Work Order ID 56876

Item Name: Head Rest

D3303-041 HEAD REST

DRAWING NO. D3303	TITLE HEAD REST	REV. B	DART AEROSPACE LTD ENGINEERING ORDER		D.E.O. NO. D3303-B-1	SHEET NO. SHEET 1 OF 1	SCALE NTS
DRAWN AJS	CHECKED <i>[Signature]</i>	MFG. APPR. <i>[Signature]</i>	APPROVED <i>[Signature]</i>		DE APPR. <i>[Signature]</i>		
DATE 08.10.15	DATE 08.10.15	DATE 08/10/16	DATE 08/10/16		DATE 08/10/16

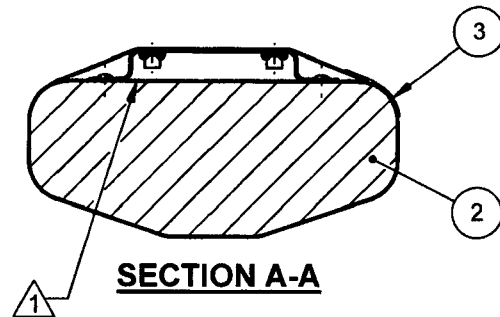
SHEET 1 ADD 1300L ADHESIVE BY 3M TO NOTE 1 AS FOLLOWS:

IS:

NOTES:

- 1) BOND D3305-1 FOAM TO D3303-043 BRACKET ASSEMBLY USING 3M 1300 OR 1300L ADHESIVE (0.002" TO 0.010" THICK) IN ACCORDANCE WITH MANUFACTURER'S INSTRUCTIONS
